| Advisory Action Before the Filing of an Appeal Brief | Application No. | Applicant(s) |
| | 10/665,680 | GALLUP ET AL. |

THE REPLY FILED 19 December 2006 FAILS TO PLACE THIS APPLICATION IN CONDITION FOR ALLOWANCE.

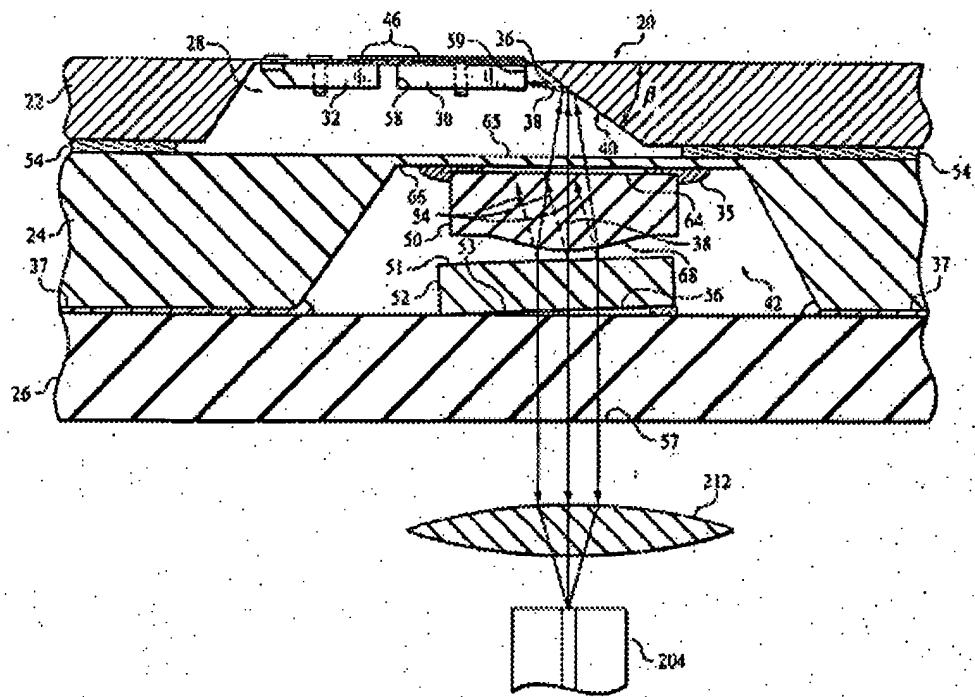
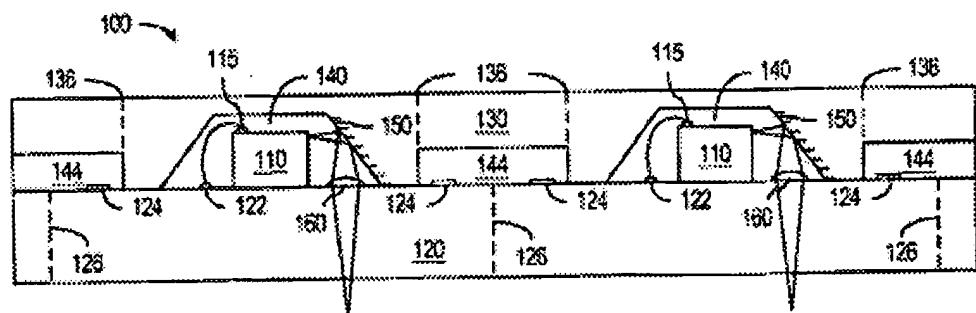
Continuation of 11. does NOT place the application in condition for allowance because: With all due respect, the exposed trace is taught in paragraph [0026] as the "metalization within the recess and not the hermetically sealed feed through connections (46). Since applicant chooses to not show the conductive traces (Specification Para [0025] page 5) in the disclosed figures, then examiner respectfully request applicant to explicitly show where the conductive traces are in applicant's disclosure and how Killian's disclosure of the metalization within the recess fails to meet the instant limitation. Regarding applicant's argument of the light not passing through the sub-mount is a matter of lexicography. If applicant contends otherwise, examiner respectfully request an analysis of applicant's invention is conceptually different from Killian in a side-by-side figures comparison, attached herein. .
